Decision Report

Refresh Vacluse and Diamond Bay Project

December 2020

Figure 1 - Servicing catchments of the existing ocean outfalls at Vaucluse and Diamond Bay

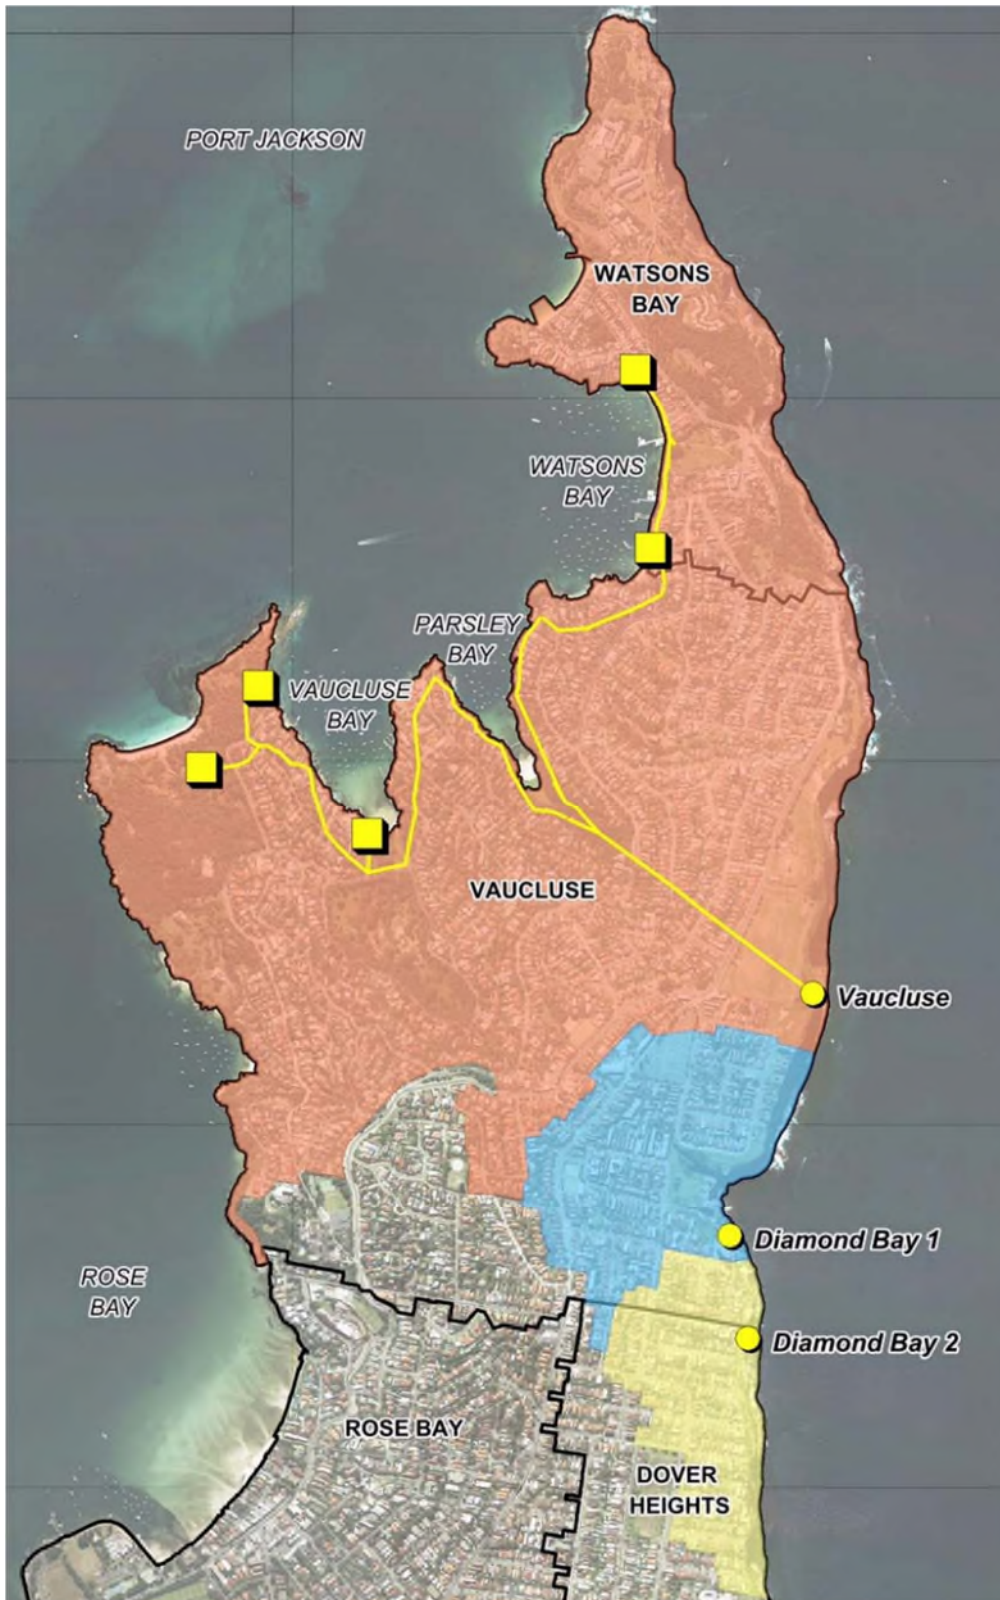
Question regarding the current location of discharge of wastewater in Vacluse and Diamond Bay, and what catchments the outfalls are servicing. Also concern regarding potential discharge into Parsley Bay and why this area was chosen for the location of the wastewater pump station.

There are currently three ocean outfalls located in Vacluse, Diamond Bay and Dover Heights that discharge untreated wastewater at the cliff face. Figure 1 shows the location and current catchments serviced by each of the three outfalls. It is worth noting that sections of Rose Bay and Dover Heights (non-coloured area in Figure 1) are already connected to the Bondi WWTP.

In order to collect the wastewater from the Vacluse catchment, the existing large wastewater infrastructure shown in yellow in Figure 1 needs to be intercepted. The existing network has five pumping stations and gravity pipes which transfer flows to Parsley Bay. The Vacluse Ocean Outfall Sewer (VOOS) starts from Parsley and terminates at the cliff face of the Christenson Park. The infrastructure converges near Parsley Bay before it flows via the ocean outfall pipe. As such, Parsley Bay is the ideal location to divert the flow away from the ocean outfall as it requires minimal infrastructure and disturbance to the community.

There will be no planned discharge of wastewater into Parsley Bay. All wet weather overflows will be diverted to the existing Vacluse outfall via the VOOS as per the current operation.

The yellow boxes in Figure 1 below show the locations of existing wastewater pump stations at Watsons Bay and Vaucluse Bay.
